Response to Section 92 Request for Application APP-2010014267.02

This letter is in response to the request for further information obtained from the Horizons Regional Council on 18th September 2018. The request for further information is in relation to Tararua District Council's resource consent application for the Woodville Wastewater Treatment Plant (APP-2010014267.02). Please see below our response:

Woodville WWTP Mass Balance Calculation

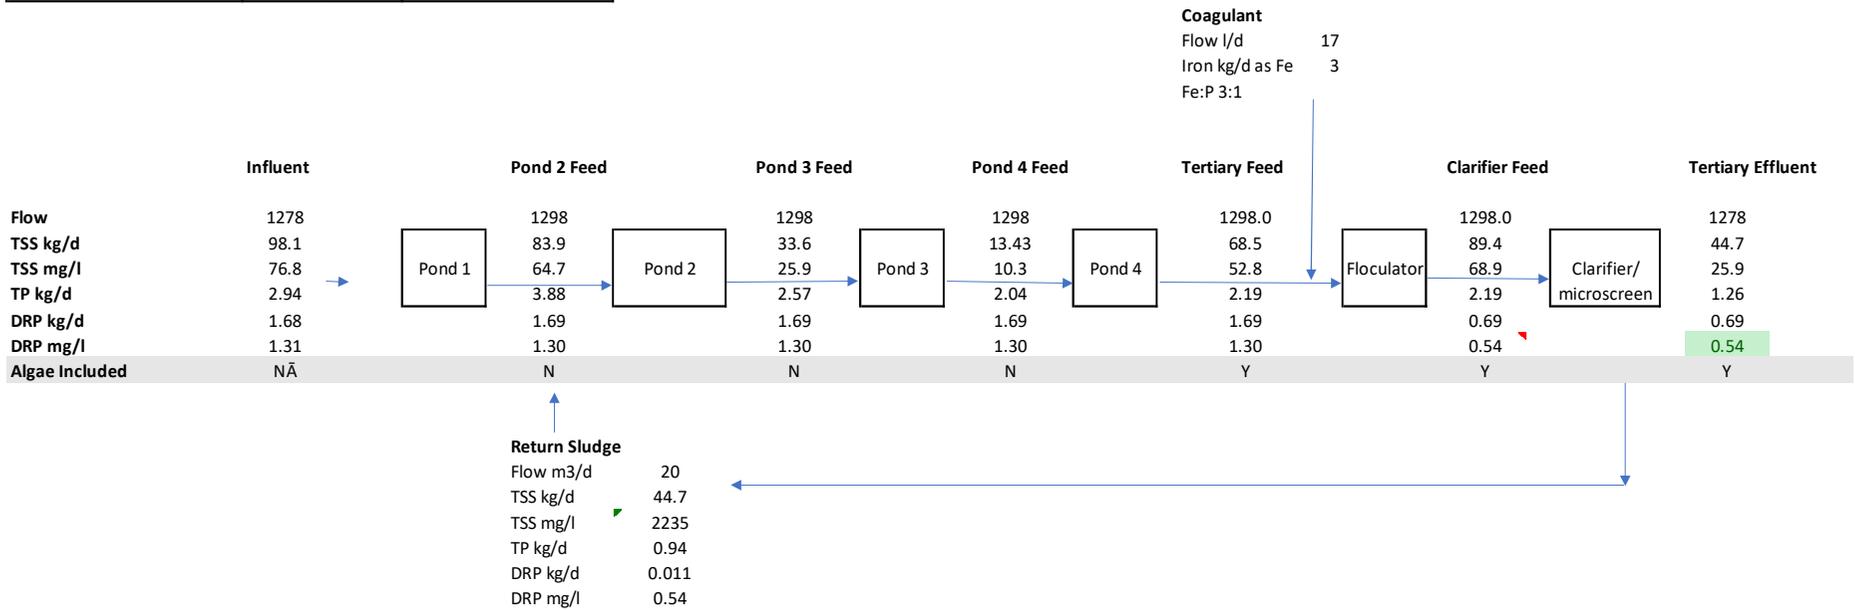
2. The solids load returned from the clarifier sludge and filter backwash to Pond 1 in kg/day and as a percentage of the influent TSS load.

Solids return load is estimated in the mass balance, assuming only 50% removal across the tertiary process. Higher solids removal is expected under most conditions. This assumes that all solids produced from chemical reaction form ferric phosphate. In reality, other solids will precipitate, particularly ferric hydroxide, which will have a lower solid loading in the return stream by mass. For this demonstration, the TSS make 45% of the theoretical incoming load. Solids will be returned to Pond 2 (not as shown in process flow diagram to pond 1). For the mass balance it is assumed that TSS are reduced by 60% per pond, so no significant impact on the TSS passing to the tertiary system is noted.
